Re: Recall number 07V-561

can-am**SAFETY**
CAMPAIGN**ROADSTER**
WARRANTY
Bulletin

Date: **December 21, 2007**Subject: **Brake Fluid Reservoir Caps
Replacement**No. **2008-?
(TBD)**

Step 1 : Brake Fluid Reservoir Caps Replacement

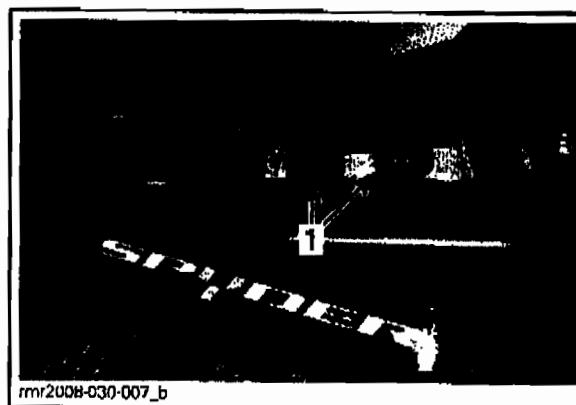
It was identified that a limited quantity of Roadster Spyder vehicles may have two defective brake fluid reservoir caps and an abnormal quantity of air in the service brake system. This could potentially degrade brake performance.

Clean brake fluid reservoir caps [1] and surrounding area.

Remove brake fluid reservoir caps from vehicle. Keep and return obsolete caps according to the claim procedure.

Install both improved brake fluid reservoir caps (P/N 219 800 058) onto vehicle.

Step 2 : Brake System Pressure Validation

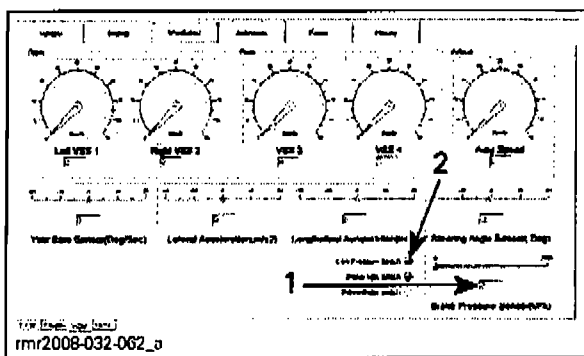
As per the above picture :

- [1] : Brake pressure sensor value
- [2] : Low pressure switch button

Slowly depress the brake pedal (only once) until you reach **3500 kPa (508 PSI)** at the brake pressure sensor.

If low pressure switch button is still off when you reached the required pressure the validation is successful.

If low pressure switch button turns on before reaching **3500 kPa (508 PSI)** perform the following additional steps :

If the average is **ABOVE OR EQUAL 3500 kPa (508 PSI)**, the validation is successful.

If the average is **BELOW 3500 kPa (508 PSI)** perform the *BRAKE FLUID BLEEDING PROCEDURE (COMPLETE SYSTEM)*. Refer to Roadster Warranty Bulletin no. 2008-1 for details.
